WESTTOWN TOWNSHIP PLANNING COMMISSION MEETING AGENDA

WESTTOWN TOWNSHIP PLANNING COMMISSION MEETING MINUTES

- C. Full size Plan titled “Preliminary/Final Land Development Plan for Westtown School – Oak Lane Project” consisting of 49 Sheets (1-23, 24A, and 24-48 of 48), prepared by ELA Group, Inc., dated January 27, 2023 and last revised September 19, 2023.

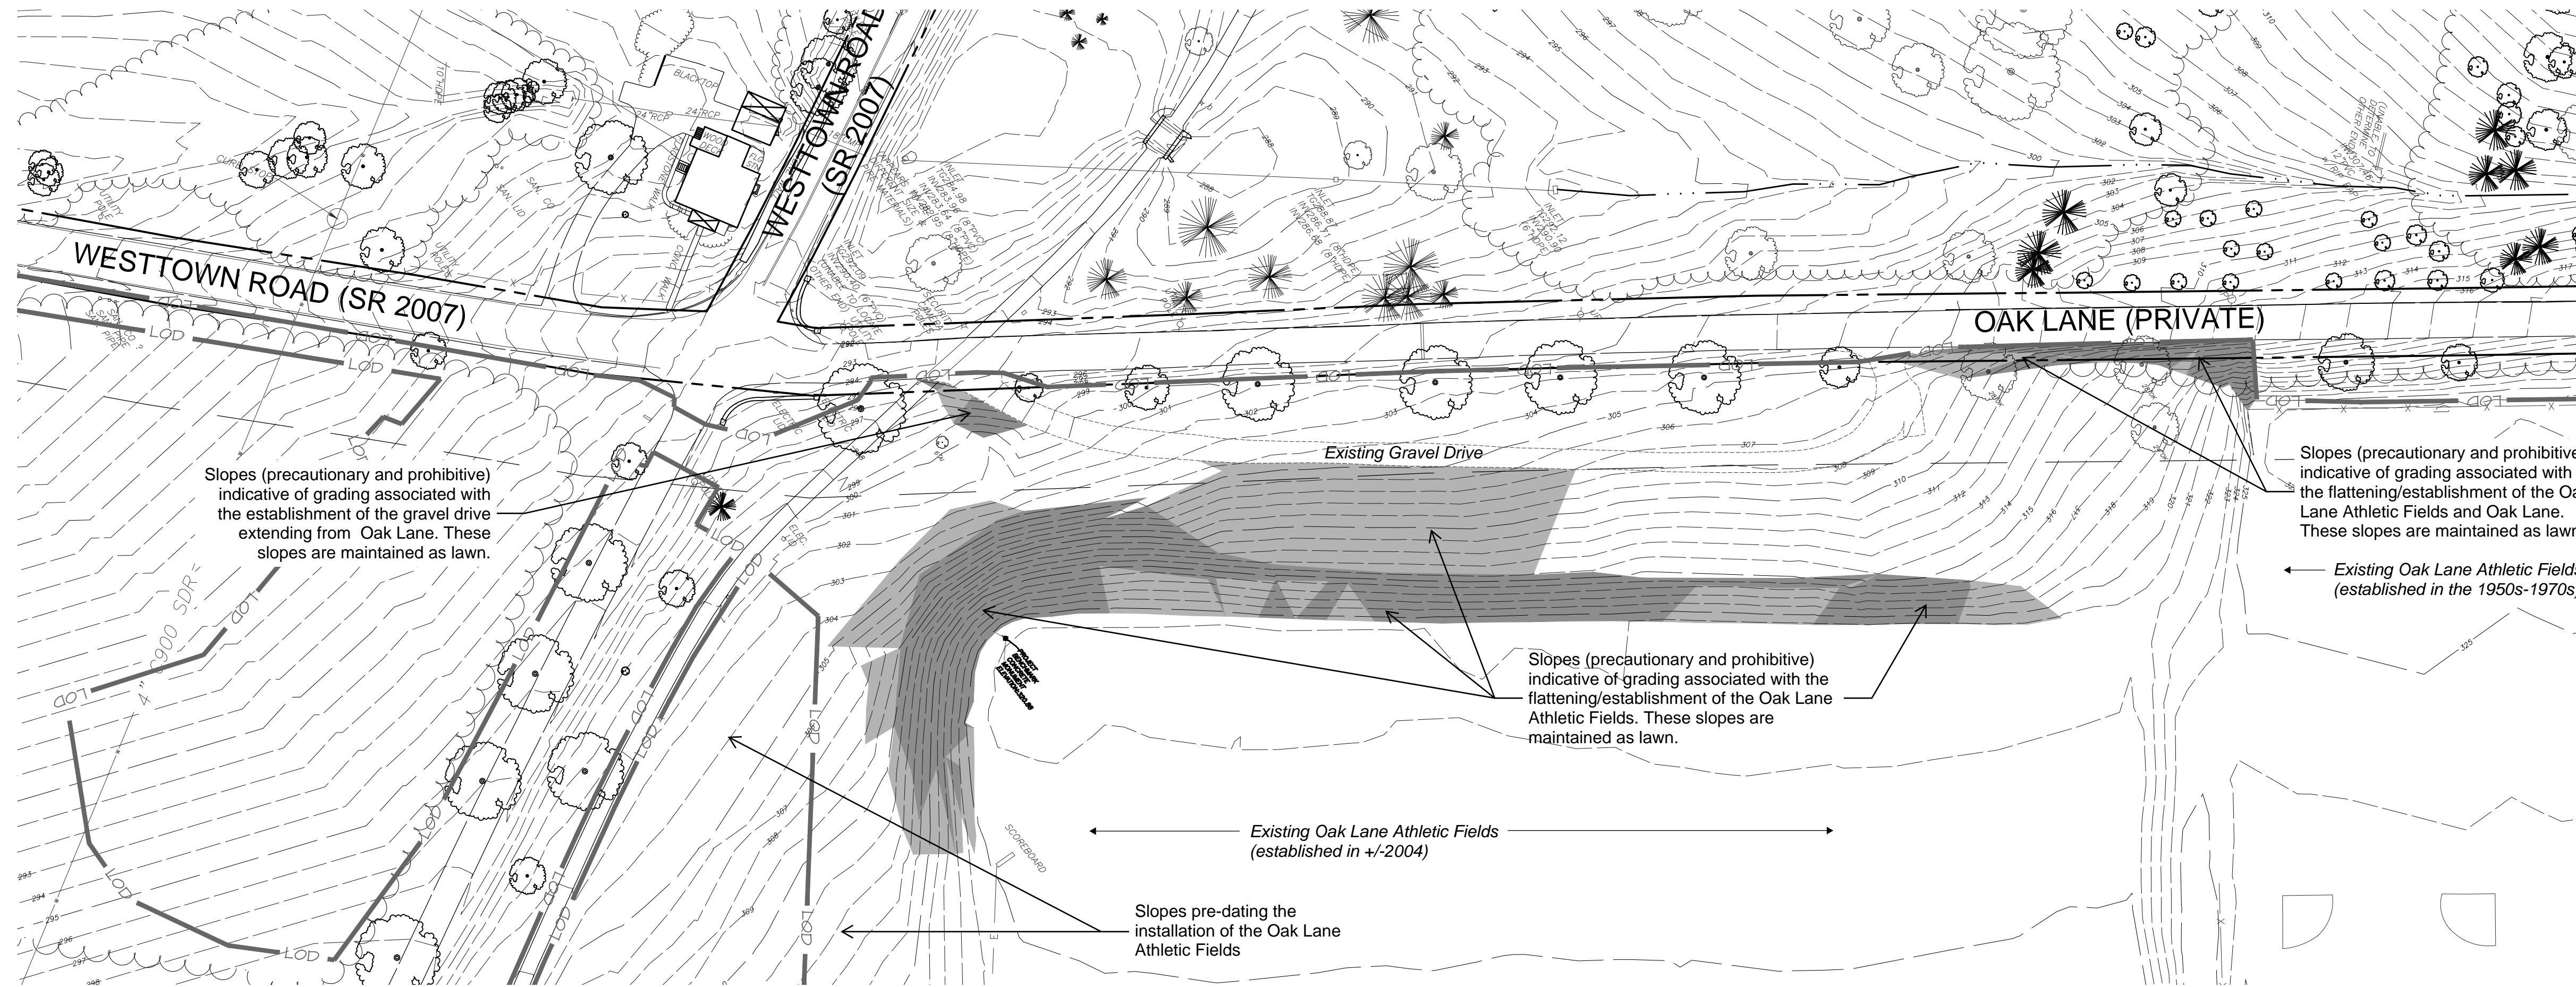
1. Comments #66 and #67 regarding the determination that the uses proposed within the Steep Slope Conservation District are compliant with Section 170-402.

The applicant proposes several improvements within the areas of steep slopes, primarily removal of an existing gravel access drive, conversion of an existing gravel/grass parking area into paved parking with associated sidewalks and construction of a new support building. As per Section 170-402.D.(2), the erection of a building within areas of prohibitive slopes is not permitted by right. As per Section 170-402.D(3), the same uses as permitted in the underlying (A/C) Zoning District are allowed, which includes primary or secondary school (via special exception) and accessory uses, and are subject to the requirements described in said section, including the requirement for an erosion and sedimentation control plan and/or stormwater management plan. The applicant reasons that the existing slope areas might have been artificially created and provided the Slope Mapping Exhibit for Westtown School – Oak Lane Projects Plan Set (sheets 1 to 3) dated June 23, 2023 that shows the extent of the existing precautionary (15-25%) and prohibitive (> 25%) slopes in relation to the existing features (i.e., gravel access drive and athletic fields). The plan sheets also show aerial imagery captured over the years, from as early as 1921 to 2017, and includes excerpts from the United States Geological Survey (USGS) topographic maps from different time periods with contour lines. The applicant notes the slopes are indicative of prior grading activities associated with the establishment of the gravel drive extending from Oak Lane, with the flattening of the Oak Lane and the establishment of athletic fields. Currently, these slopes are being maintained as lawn.

Based on the information provided by the applicant, it is evident that changes in topography has occurred due to man-made activities. Therefore, the Zoning Officer has no objections to proposed modifications to steep slope areas created as described by the applicant subject to approval by the Township Engineer and the Board of Supervisors. Furthermore, it is recommended that the applicant depicts and labels the extent of the artificial slope areas with the amount of disturbance on the plan.
